Project	<b>IEEE 802.16 Broadband Wireless Access Working Group</b> < <a href="http://ieee802.org/16">http://ieee802.org/16</a> >	
Title	<b>Clarification on the allocation for beamformed pilots</b>	
Date Submitted	<b>2005-01-11</b>	
Source(s)	Qinghua Li, Xintian Eddie Lin, Nageen Himayat, Minnie Ho, Randall Schwartz, Jose Puthenkulam <b>Intel Corporation</b>	<a href="mailto:qinghua.li@intel.com">qinghua.li@intel.com</a> Voice: +1-408-765-9698
Re:		
Abstract	Clarification on the allocation for beamformed pilots	
Purpose	Adoption of proposed changes into P802.16e <del>Crossed out indicates deleted text,</del> <u>underlined blue indicates new text change to the Standard</u>	
Notice	This document has been prepared to assist IEEE 802.16. It is offered as a basis for discussion and is not binding on the contributing individual(s) or organization(s). The material in this document is subject to change in form and content after further study. The contributor(s) reserve(s) the right to add, amend or withdraw material contained herein.

# Clarification for the Allocation of Beamformed Pilots

Figure 1 Illustration of a non-beamformed midamble from 4 BS antennas and beamformed pilots for 2 spatial channels.

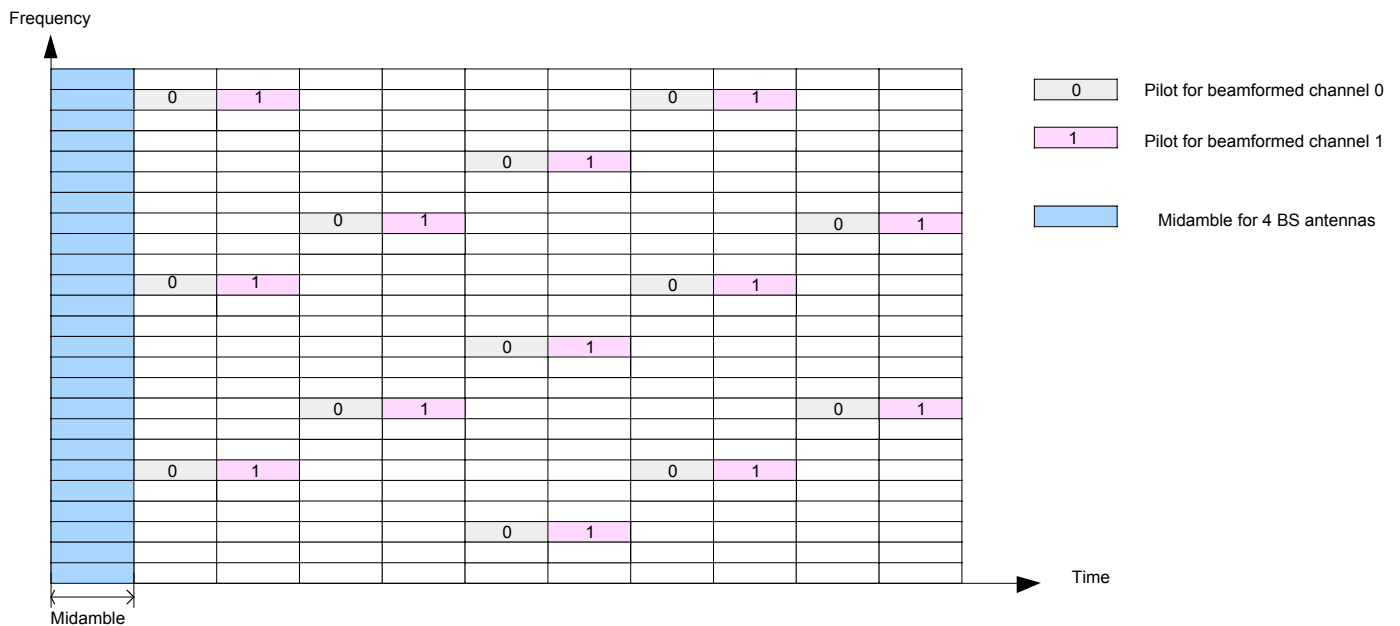
Dedicated pilot for MIMO beamforming mode is accepted by the D5a standard in November meeting. The dedicated pilots are beamformed to send enhanced training signals for the beamformed spatial channels to one or multiple subscriber stations, and other unintended stations usually can not receive them correctly. According to section 8.4.8.3.1 in D5a, a pilot has to be assigned for each BS antenna. However, this is not necessary and efficient for the dedicated pilot case defined in section 8.4.5.3.4 because only the beamformed spatial channel carrying data needs a pilot. For example, a 4x2 link with 4 BS transmit antennas and 2 SS receive antennas can send at most 2 spatial streams. The BS doesn't need to send pilots for its 4 antennas while it employs dedicated pilots for the beamformed spatial channels. Therefore, the BS only need to send pilots for at most 2 (rather than 4) spatial channels using the pilot allocation defined in section 8.4.8.3.1. This not only reduces pilot overhead but also improves channel estimation at the SS. An example is shown in Figure 1.

When the data allocations are transmitted over m beamformed spatial channels and the Dedicated Pilots bit is set to 1, the dedicated pilots are sent only over the m beamformed spatial channels that carry data.
